CROW BUTTE RESOURCES, INC.

Re: Docket No. 40-8943
License No. SUA-1534
Annual Report of Changes, Tests, or Experiments

2004 SERP Evaluation Index

Evaluation Report – SERP 04-01

Figure 5.1-1: Crow Butte Resources Organizational Chart

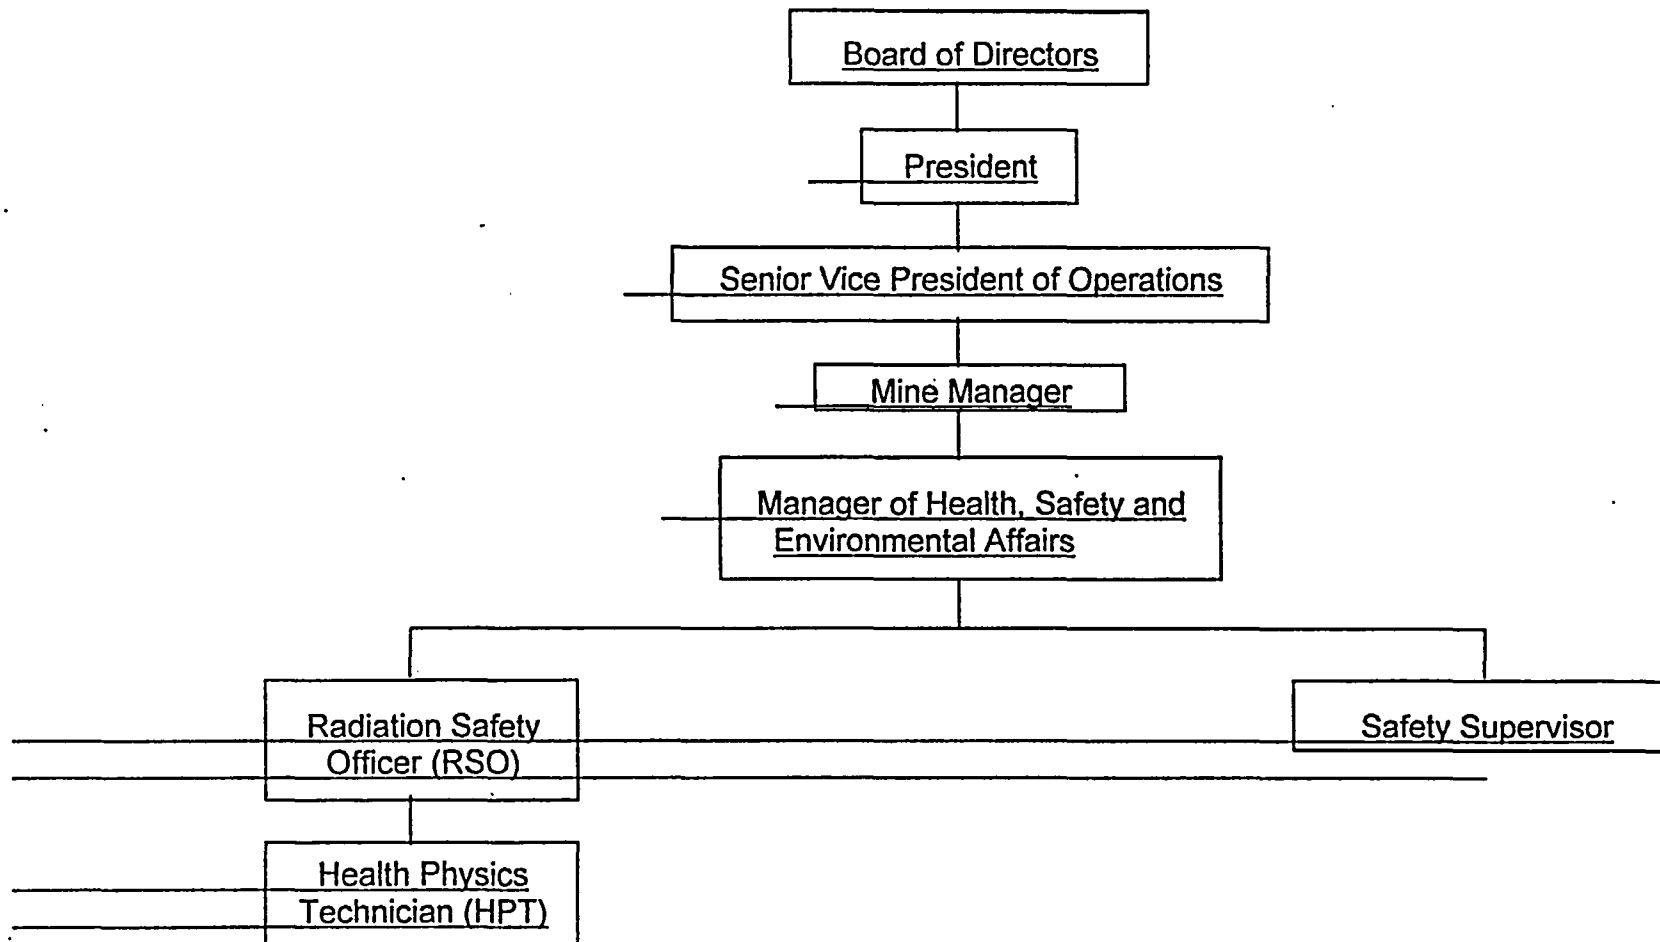
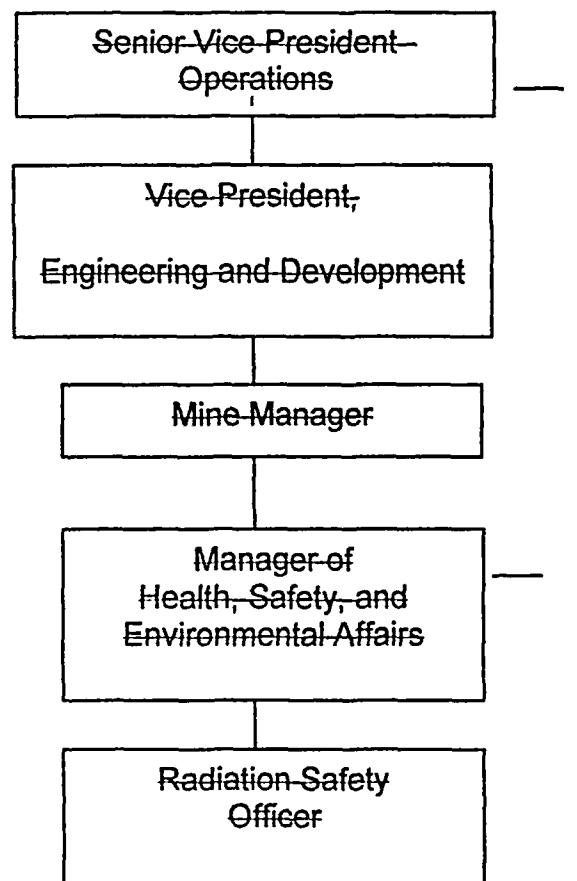
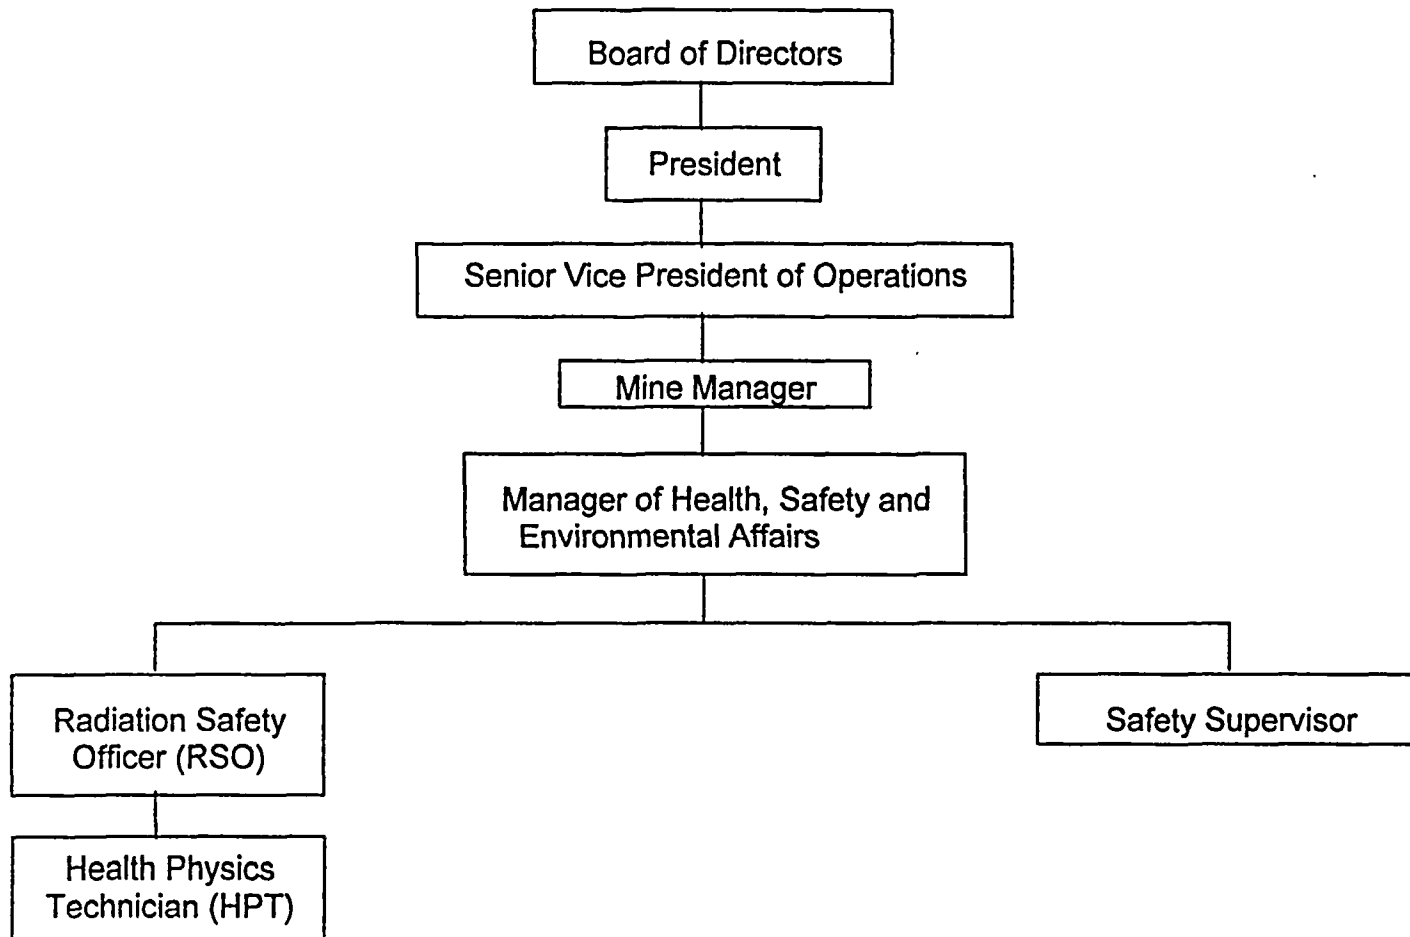
2. An organizational change has been made that indirectly affects the reporting responsibilities of the radiation safety staff. Specifically, the reporting for the Mine Manager has been changed as shown in the revised Figure 5.1-1 from the approved application. The Mine Manager now reports directly to the Senior Vice President – Operations. Since the RSO reports to the Manager of Health, Safety, and Environmental Affairs who in turn reports to the Mine Manager, a change in the reporting for the Mine Manager will indirectly affect the radiation safety staff reporting.

The Mine Manager is responsible for all uranium production activity at the project site. The Mine Manager is also responsible for implementing any industrial and radiation safety and environmental protection programs associated with operations. The Mine Manager is authorized to immediately implement any action to correct or prevent hazards. The Mine Manager has the responsibility and the authority to suspend, postpone or modify, immediately if necessary, any activity that is determined to be a threat to employees, public health, the environment, or potentially a violation of state or federal regulations. The Mine Manager cannot unilaterally override a decision for suspension, postponement or modification if that decision is made by the Senior Vice President of Operations and/or the Manager of Health, Safety and Environmental Affairs. The Mine Manager reports directly to the Senior Vice President of Operations.
